World Forum for Harmonization of Vehicle Regulations**Working Party on Passive Safety****Seventy-second session**

UN Regulation No. 127 (Pedestrian safety)**Proposal for Supplement 1 to the 04 Series of Amendments to
UN Regulation No. 127 (Pedestrian safety)****Submitted by the experts from France, Germany and the International
Organization of Motor Vehicle Manufacturers ***

I. Proposal

Figure 12
Windscreen test area

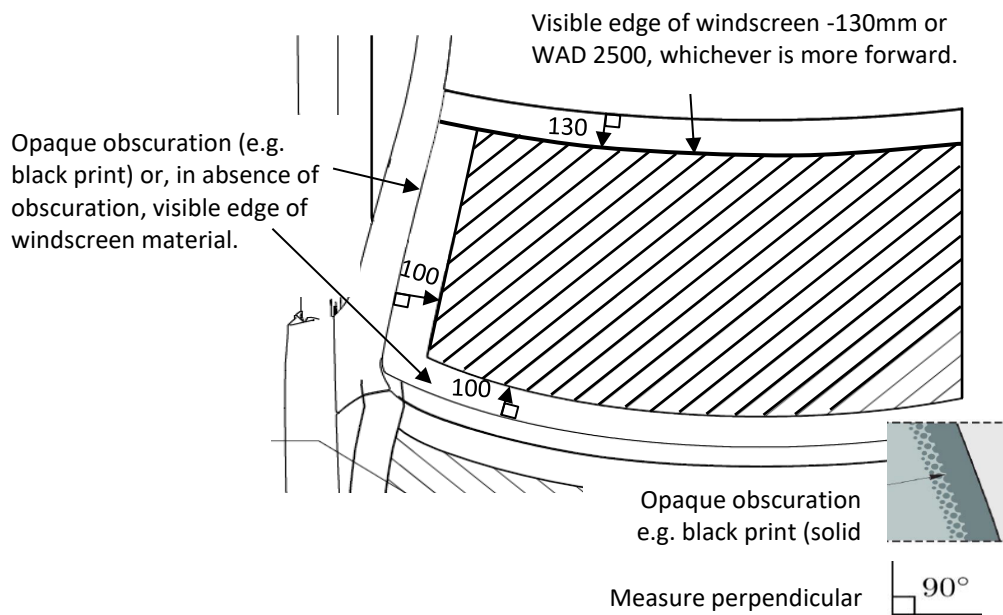
Paragraph 2.44., amend to read and insert Figures 12 and 13:

- "2.44. "Windscreen test area" is an area on the outer surface of the windscreen. It is bound (**see figure 12**):
- (a) In the front, by a line 100 mm rearward to the opaque obscuration of the windscreen. In case of absence of the opaque obscuration, the line is measured from the front visible edge of the windscreen material.
 - (b) In the rear, by a WAD 2,500 or a line 130 mm forward to the rear visible edge of the windscreen material, whichever is more forward at a given lateral position.
 - (c) At each side, by a line 100 mm inside the opaque obscuration of the windscreen. In case of absence of the opaque obscuration, the line is measured from the side visible edge of the windscreen material.

For (a) and (c): the distances of 100 mm are to be measured with a flexible tape held tautly along the outer surface of the vehicle at an angle of 90° to the tangent line to the opaque obscuration limit or in case of absence of the opaque obscuration, from the visible edge respectively.

For (b): the distances of 130 mm is to be measured with a flexible tape held tautly along the outer surface of the vehicle at an angle of 90° to the tangent line to the rear visible edge of the windscreen.

Figure 13
Upper corner definition with "shortest distance"

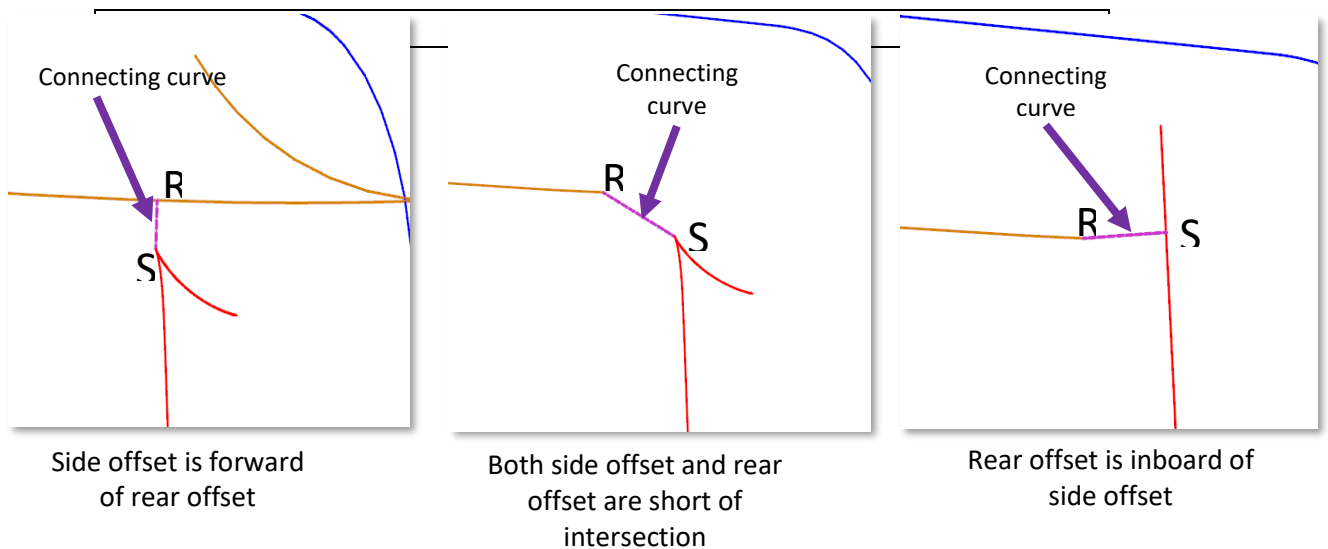
Depending on the geometry, in case there is no intersection between (b) and (c), resulting in an open test area, then the marking shall be modified using the shortest distance to close the open test area (see figure 13).

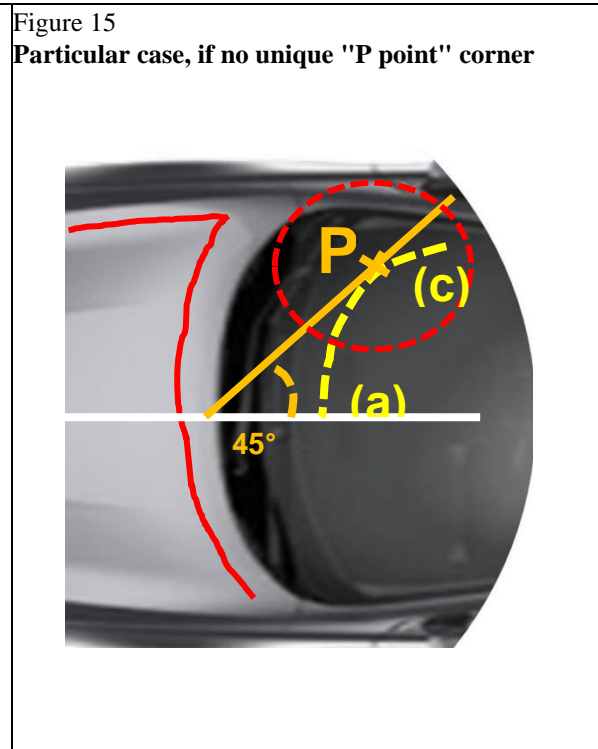
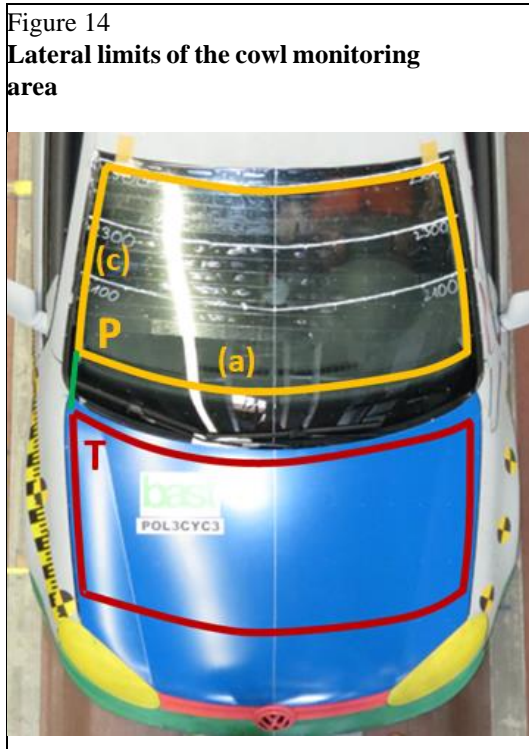
Paragraph 2.45., insert Figures 14 and 15 and amend to read:

At each side, the cowl monitoring area is bound by the TP line (see figure 14), where:

- (a) the "T point" is the rear corner of the bonnet top test area; and
- (b) the "P corner point" is the lower corner of the windscreen test area; using a flexible tape held tautly from point T to P.

If there is no unique "P point" where the lines defined in 2.44 (a) and (c) intersect, then the "P point" is defined by the first contact of a vertical plane intersecting the vertical longitudinal vehicle center-plane at an angle of 45° with the (a)-(c) transition of the windscreen test area boundary, as shown in Figure 15.

Figure 16

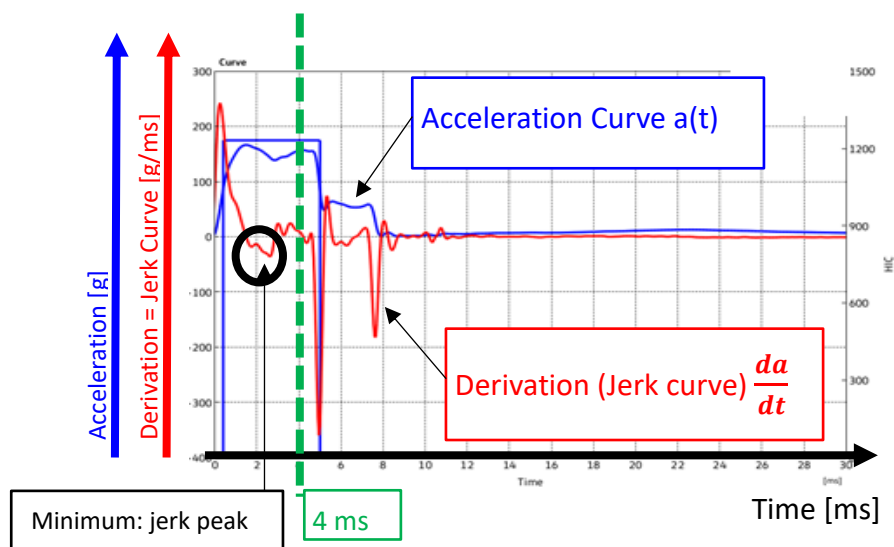
Paragraph 2.48., insert Figure 16 and amend to read:

- (a) The absolute value of the minimum value of the derivation of the headform acceleration versus time is ~~below~~ **less than** 180 g/ms ~~for~~ **within** the first 4 ms after the initial contact of the headform to the windscreen, **as shown in Figure 16**; or

$$\left| \min \left(\frac{da}{dt} \right) \right| < 180 \text{g/ms, for } 0 < t < 4 \text{ms}$$
